hp Model 4800A Vector Impedance Meter  
serials prefixed 805 and below

Thermistor A17R14 Replacement  
hp Modification Kit 04800-61043

Modification Kit 04800-61043 is a replacement kit for thermistor 0837-0045 in the hp Model 4800A Vector Impedance Meter, serials prefixed 805 and below. Later instruments do not use the thermistor.

Figure 1. Feedthru Location - A17 Board

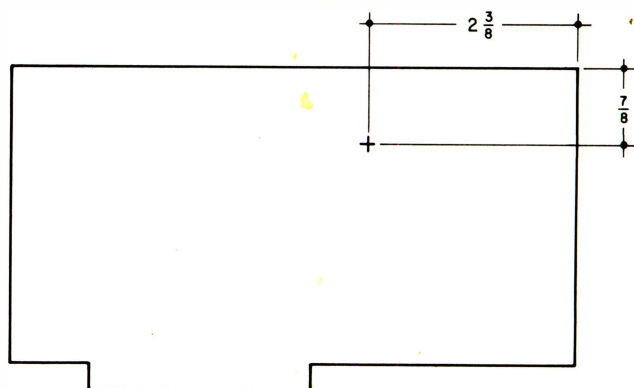
1. Remove power from instrument.
2. Remove R1, 2.87 K resistor mounted on TEST-OPERATE Switch, S1. (located between XA14 and XA16).
3. Remove A17 (Stock No. 04800-61002) from the instrument. Remove thermistors R14 and R15 including shock absorber and strap.
4. Replace R13 with jumper.
5. Drill (7/32") (5.5 mm.) hole in location shown in Figure 1. **CAUTION:** Start with a small size drill and enlarge hole in steps to prevent drill from seizing.
6. Install press-fit feedthru.

7. Connect short wire from hole "A" (Figure 2) to feedthru on back side of board.

Figure 2. A17 After Modification

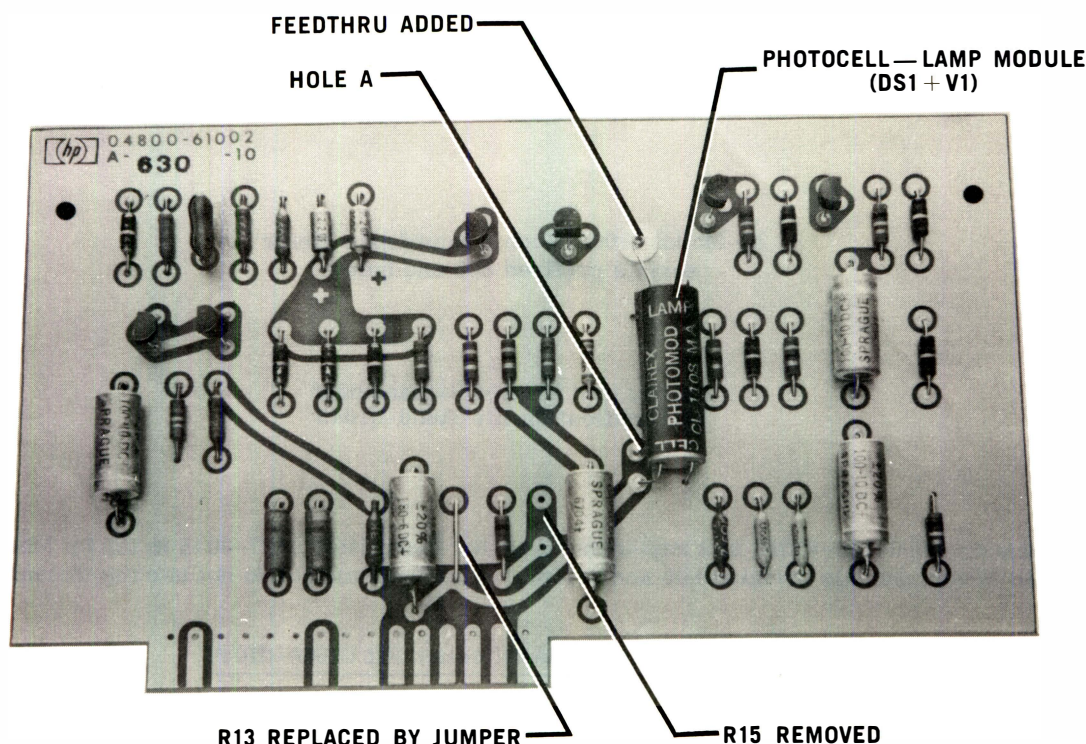
8. Install photocell-lamp module, DS1 + V1. Cell end of module is mounted closest to the plug-in connections.

Figure 2 shows A17 after modification.

Figure 3. Feedthru Location - A14 Board

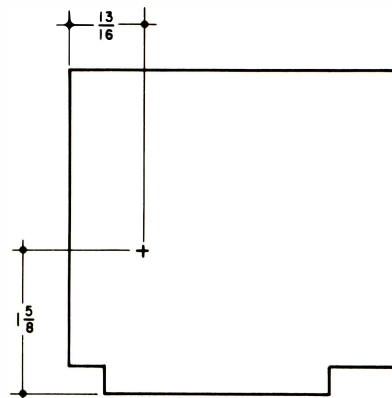
12. Drill (7/32") (5.5 mm.) hole in location shown in Figure 3. As in step 4 above, enlarge hole in steps to final size.

13. Install feedthru; clip lead off back of board.

Figure 4. A14 After Modification

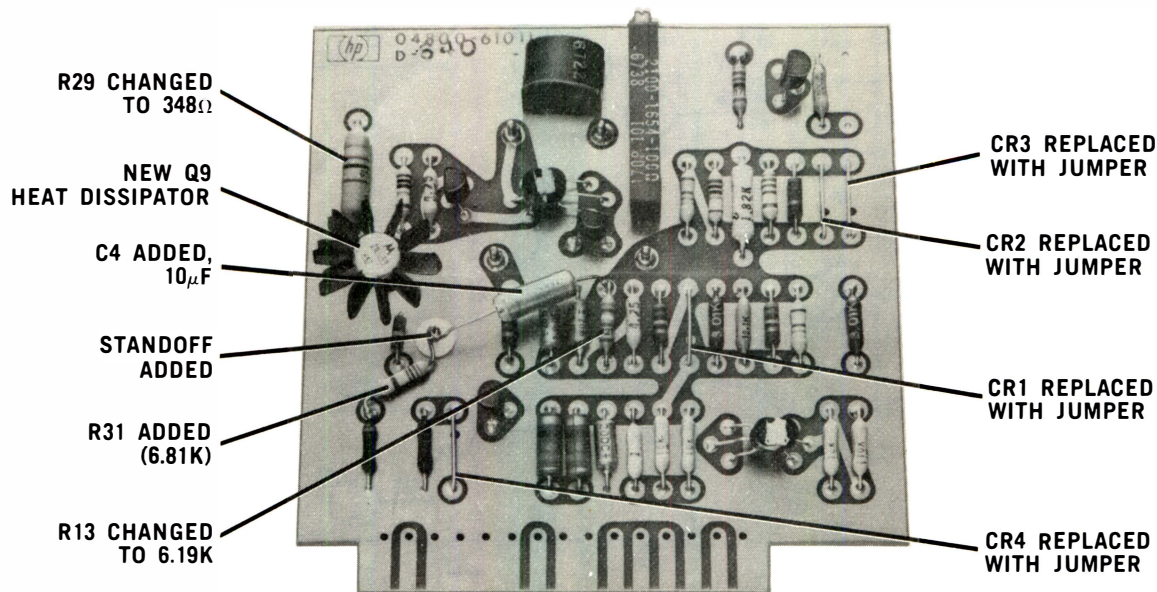
14. Replace R13 with 6.19 K $\Omega$ .

15. Replace R29 with 348  $\Omega$ .

16. Connect R31, 6.81 K $\Omega$  from feedthru to R30. Tack-solder to R30.

Figure 4 shows A14 after modification.

17. Connect C4, 10  $\mu$ F from standoff to R13. Note polarity: + lead to feedthru.

18. Place heat dissipator on new Q9; install on board with 1/2" leads. Leads must be long enough to allow moving Q9 and heat dissipator away from chassis. Q9 case must not be grounded; it is electrically connected to the collector.

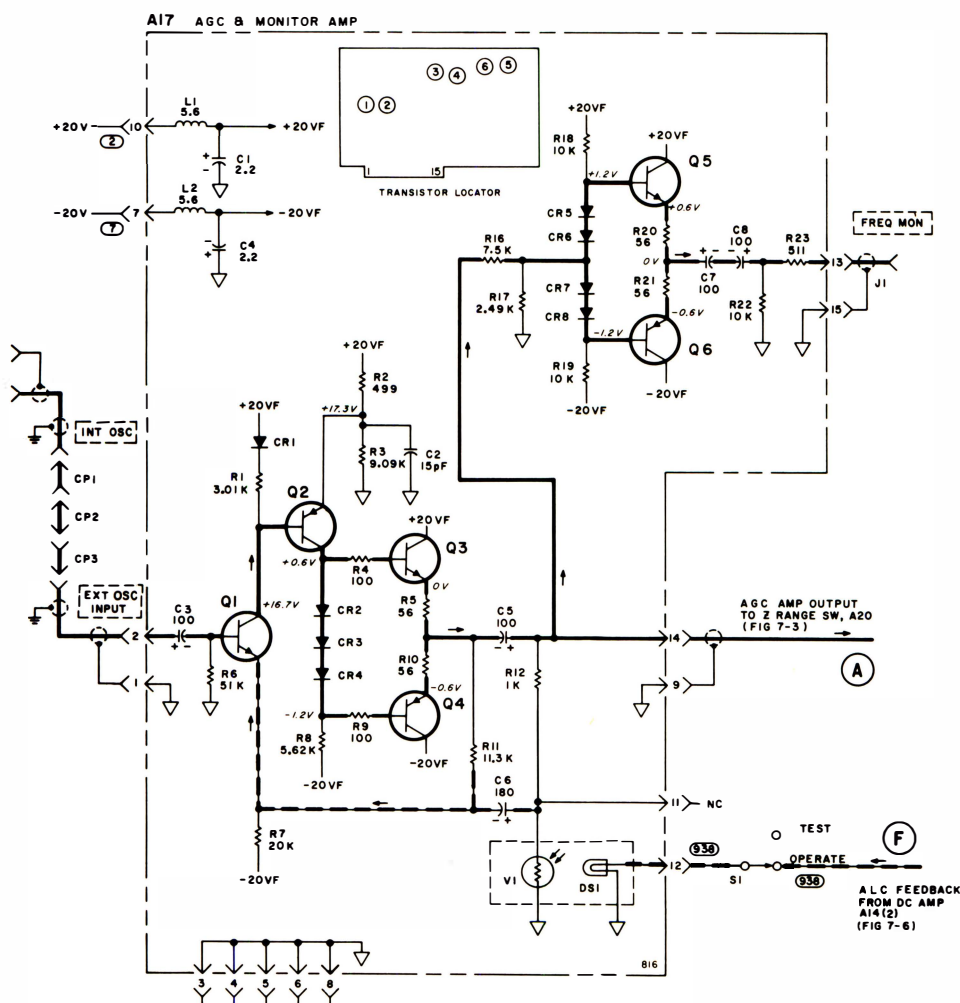
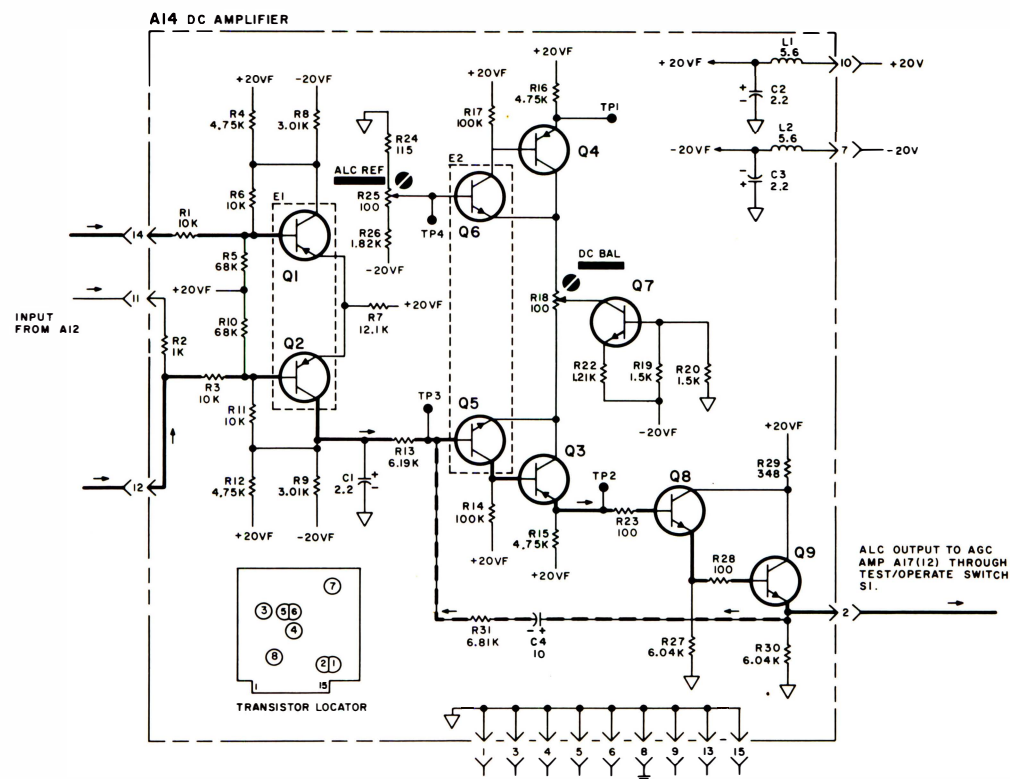
Revised A14 and A17 schematics are included in this Service Note which should be kept for future reference.

Page 7-17, Figure 7-8.

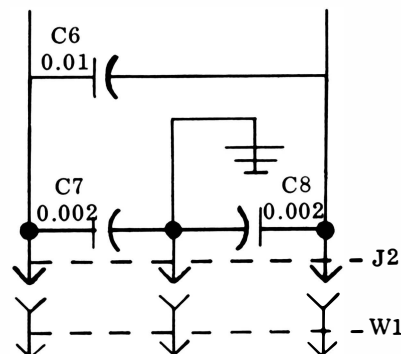
Revise the input line schematic as shown in the diagram below.
